RAMS

Airworthiness Directive: 127

Subject: Trim Tab Flutter

Models Effected: All S-7 Models Manufactured Before 1999

The drawing below shows an elevator with horn and internal weight installed.

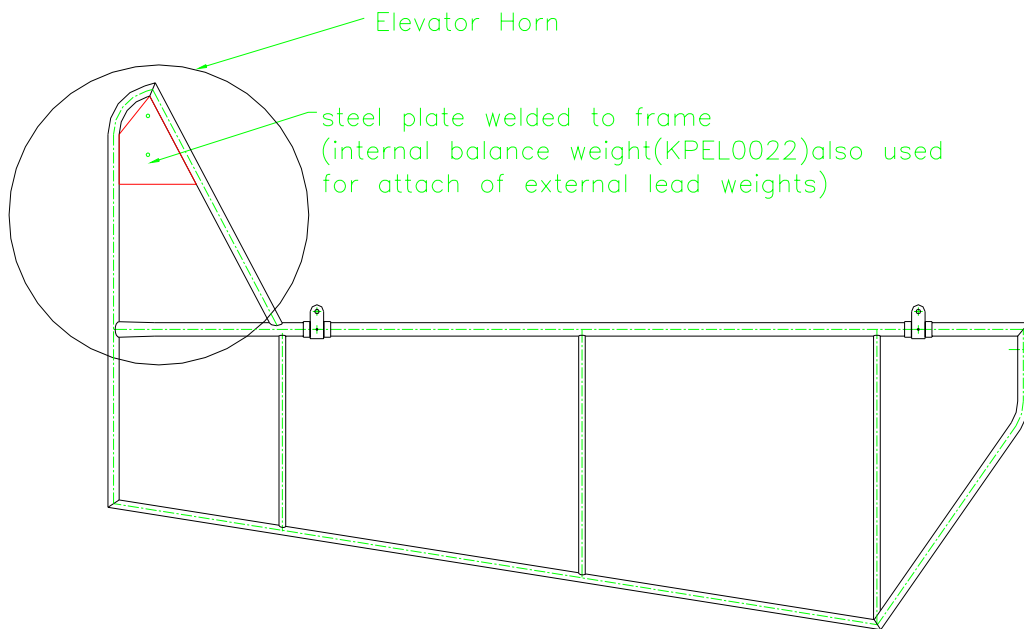
This will be easy on all elevators built after 97. These elevators have already a heavy steel plate welded in the tip of the horn to achieve some degree of balance and to attach the external lead weights.

If your elevators have these plates installed (feel through the fabric) you can simply follow the enclosed instructions for mass balancing.

If your elevator does not have the internal steel plates (Manufactured in 97 and before), we suggest installing them (Spot weld in 5 places). The plates will be available through the factory (Order: Mass balance KPEL0022). You will need two.

The plates have to be flush with the lower surface of the elevators.

After that, balance your elevator (before mounting) around the hinge line following our enclosed instructions.

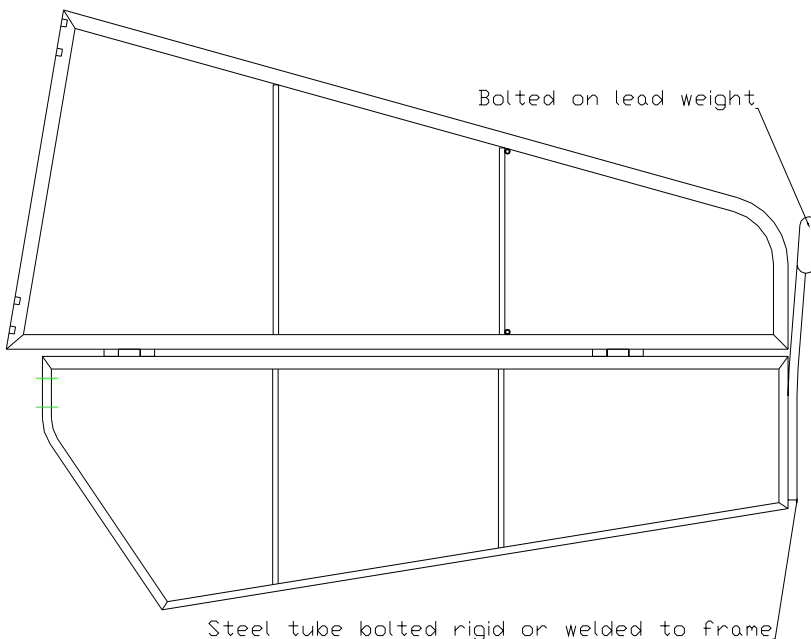
3. S-7 without horn style elevator (straight) and trim actuation through spring and cable and serial numbers after 0594132 (build after 05. 94).

We suggest substituting the horizontal stabilizer and elevator completely through new style parts. Included would be the change over to the electrical servo trim system and a 100 % static mass balance of both elevators.

We will possibly need a couple simple measurements on an individual basis.
